Minutes of **C37.09 Amendment 1 Working Group**

Spring 2023 meeting

April 18, 2023, Clearwater, Florida

**PC37.09 Standard Test Procedure for AC High-Voltage Circuit
Breakers with Rated Maximum Voltage above 1000V
- Amendment 1**

Figure 16—Dual-rating, low-temperature test sequence

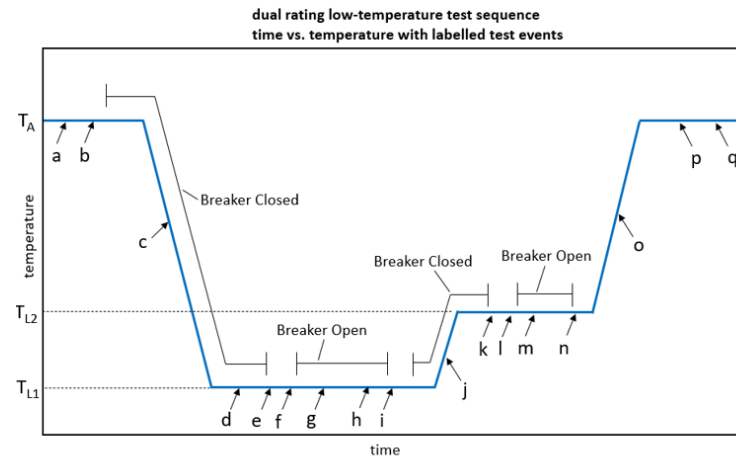
Change T_I and T_{II} to T_{I1} and T_{I2}. Reduced the soaking time. Eliminated the second tightness test.

There was a question regarding the temperatures. Standard is -30 C but the test would be to the design specifications.

There was a question whether the lower temperature should be defined and whether it will be required to start at the lower temperature and move to the higher. It was discussed that going either direction should be acceptable.

Carl Schuetz asked whether the leak test should be performed at both temperatures. The proposal is to only require it at the lowest temperature. The thinking is that the higher temperature would have a lower leak rate.

There was a question whether liquification of the gas at the lower temperature would affect the leak test. It was stated that it depended on the method used. There is always some liquefaction at the low temperatures.

A statement was made that leaving T_{11} and T_{12} undefined would allow either temperature to be performed first.

Jeremy Hensberger stated that not testing at the second temperature would not account for any damage that occurred at the lower temperature.

- Changed T_{LL} & T_L to T_{L1} and T_{L2}
- Separated steps for validation of T_{L1} and T_{L2} for clarity
- No technical changes made to procedure for validation of first (or single) low-temp rating (T_{L1})
- Modified requirements for the validation of the 2nd low temp (T_{L2}) to avoid unnecessarily long tests
 - Reduced the required soak time from 24hr to 8hr for the validation of the 2nd low Temp (T_{L2})
 - According to historical test data, 8hr is sufficient to reach temperature
 - Eliminated the requirement to perform tightness tests at the 2nd low Temp (T_{L2})
 - Performing this only at the lower T_{L1} provides the necessary leakage rate validation

Steps j through n need only be performed if a dual low-temperature rating test is being performed. Otherwise, proceed to step o.

Jeremy Hensberger and Devki Sharma will work on a proposal to modify the test procedure.

Table 14—High-temperature test sequence

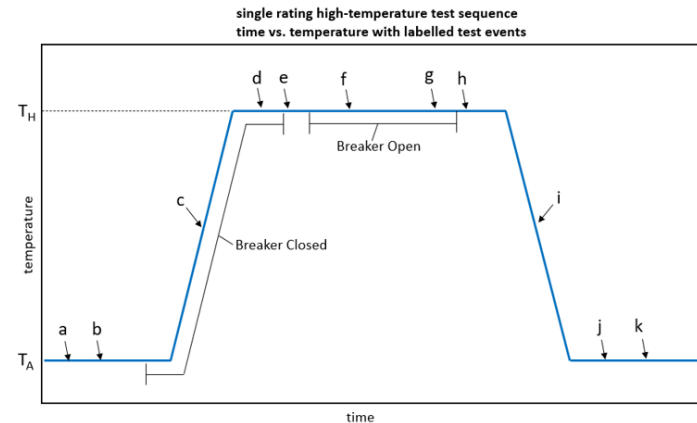
Andy Chovanec also presented the proposal for the high temperature test. Neil McCord suggested that the test be compared to IEC to make sure that the IEEE test doesn't require a second test from the IEC test.

- Mimicked procedure from Low-temp tests
- Did not include a dual rating option for high temperature testing – did not seem necessary
- Specified a maximum allowable leakage rate of $3 \times F_P$ for high-temperature tests 40°C and above
 - Matches requirement from IEC 62271-1 (2017)
- Incorporated references to High-temperature tests in sections:
 - 4.13.7 - “Low and high-temperature test object and conditions”
 - 4.13.10 - “Low and High-temperature qualification criteria”
 - 4.13.11 - “Low and high-temperature test report requirements”

- Neil McCord and Andy Chovanec will read the IEC to harmonize the tests.

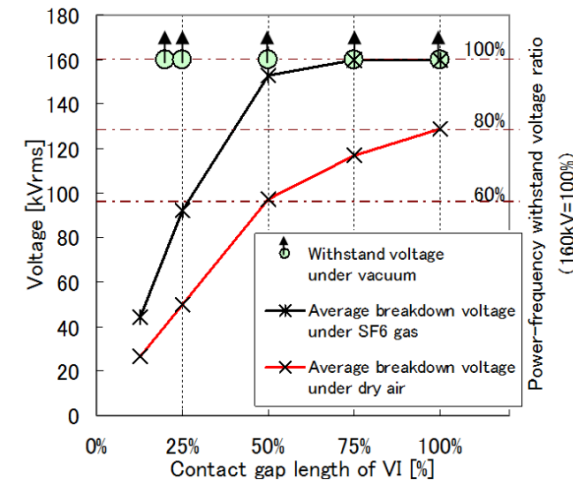
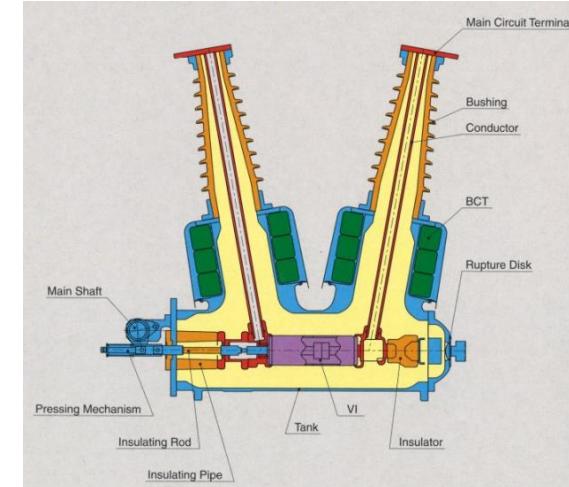
I think T10 is too specific here. Why not go for IEC approach, at least 50 % of rated voltage and at least 10 % of rated short circuit current.

Secondly, "SF6 filled" is also too specific.

- A compromised VI could allow external gaseous insulation into the vacuum enclosure.
- If the dielectric strength of the contaminant gas is sufficiently high, the device could pass a standard VCC in the open position (80% PF, 60% LI, etc.)

- Perform the VCC with a vacuum contact gap reduced to 25% of the normal open gap.
 - The data at lower-right is from an 84 kV VI indicating that even when compromised with SF6 contamination, a 25% gap would fail the VCC.

- The same test with dry air might just pass the VCC with a 100% gap.

Open question - Would the 25% proposal still apply to higher rated VI's?

- Leslie Falkingham, Neil McCord, Dan Schiffbauer, Federico Di Michele, and Harm Bannink will work on a proposal to include how to verify vacuum integrity .

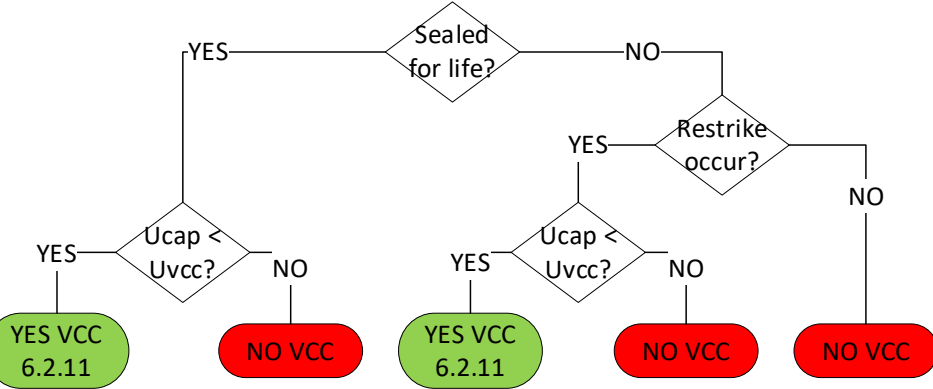
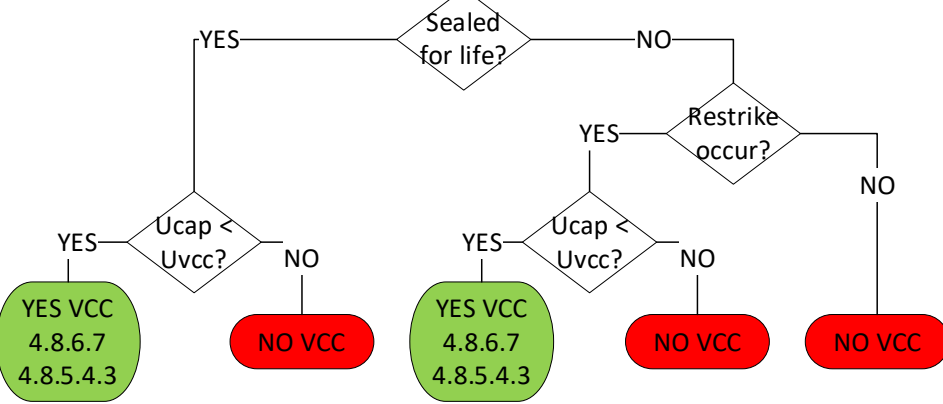
Several opportunities exist to align the voltage condition check parameters between IEC and IEEE.

Specifically after capacitive switching tests, the conditions for performing a post-test VCC are already aligned between 62271-100 (2017) and C37.09 (2018)

Jan Weisker, Leslie Falkingham, and Dan Schiffbauer volunteered to confirm these differences, investigate why they exist, and develop a proposal if they should align.
